Resource Consent Engineering Assessment Report

The application is for a land use consent for the construction and operation of an eight shed poultry breeder operation.

Applicant	Lifestyle Chickens Limited		
Address	227 Hunters Road, Dunsandel		
Application Description	To establish and operate an 8 shed poultry breeder farm		
Application Type	« Appln Type Land use Appln Type »		
Activity Level	« Activity Level Non-Complying Activity Level »		
Zone	Operative District Plan – Outer Plains Partially Operative District Plan – General Rural Zone Overlays - Electricity Transmission Line: Orion 33 to 66kV, Plains Flood Management Area, Liquefaction Damage Unlikely, Rural Density (SCA-RD3)		
Valuation No.	2412045406		
Date Sent to Assets	13 August 2024		
Return to Planning by	20 August 2024		
Planner	TBA		
Land Development input	<input checked="" type="checkbox"/>	Victor Mthamo	4 June 2024

Figure 4 – 1:200 Year Flood Maps

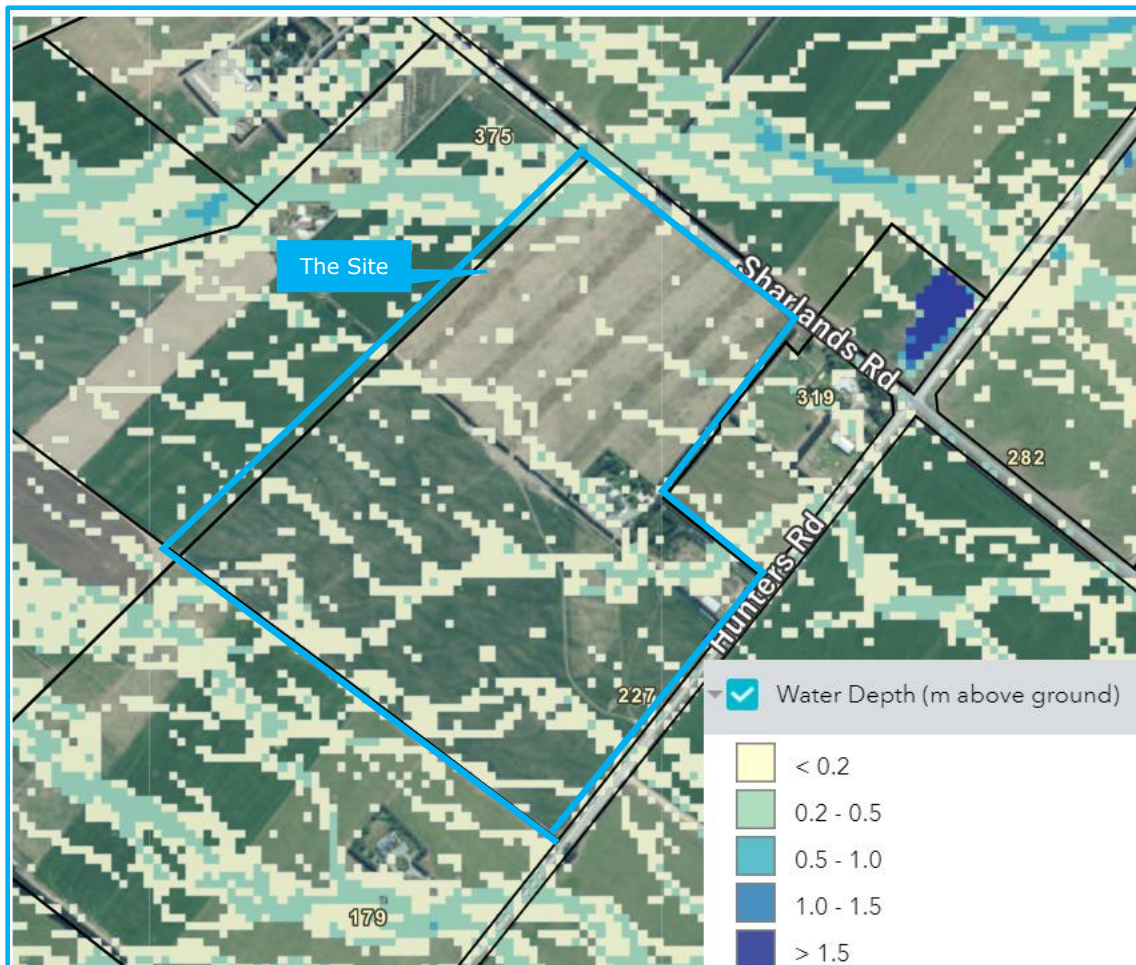
The site has low risk of flooding. While the earthworks will be significant (>10,000 m³) these will be on a flat site and for the building platforms and access. Given the nature of the proposed activity and site we have no concerns as regards the flooding.

Figure 5 – Location of the Water Race

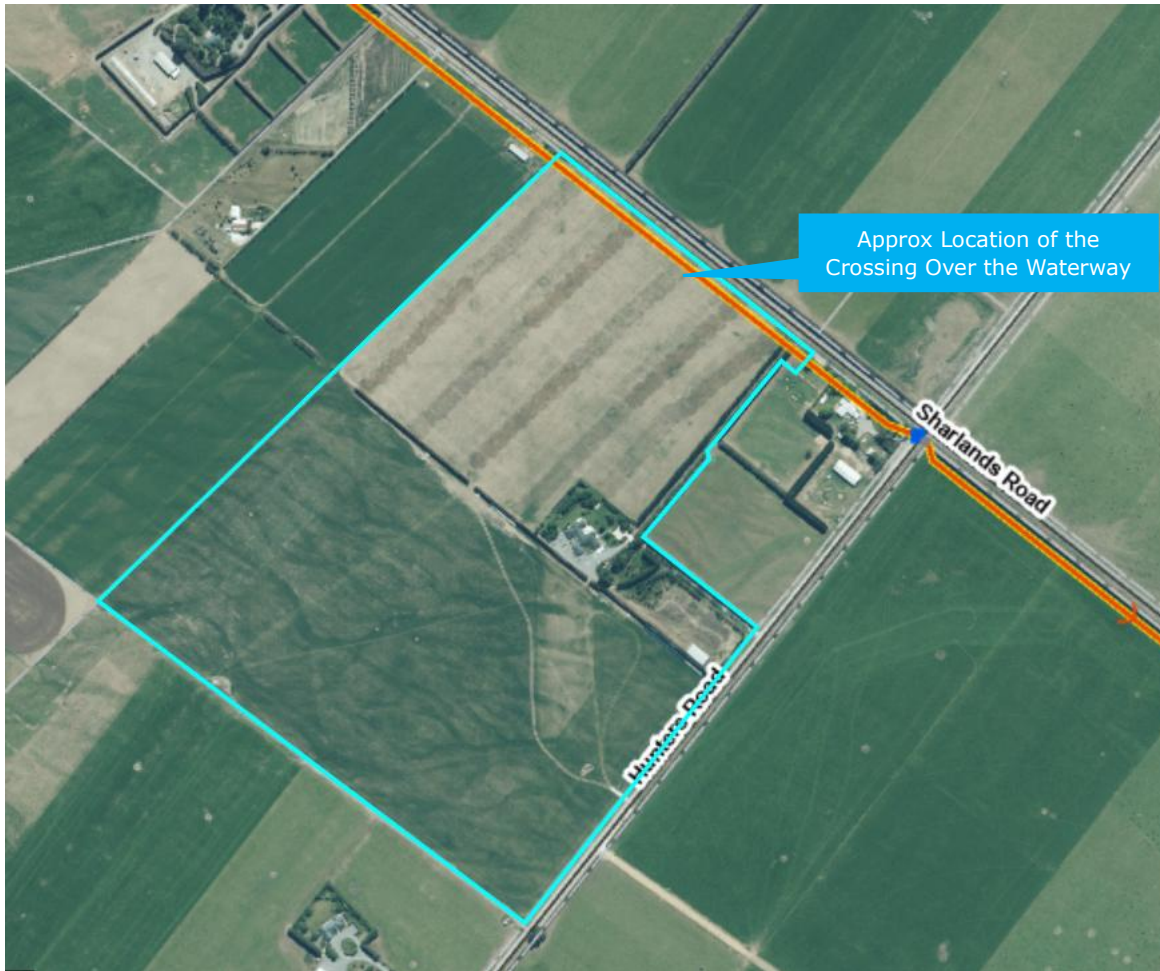
We note that the proposed access will be over the Sharlands Chanel water Race as shown in Figure 5. Engineering approval will be required for the crossing. However, as there are no details of the nature of the cross e.g. culvert vs bridge a RFI has been generated.

Can the applicant provide the proposed details of the proposed access on Sharlands Road? In particular, the nature of the crossing given the water race.
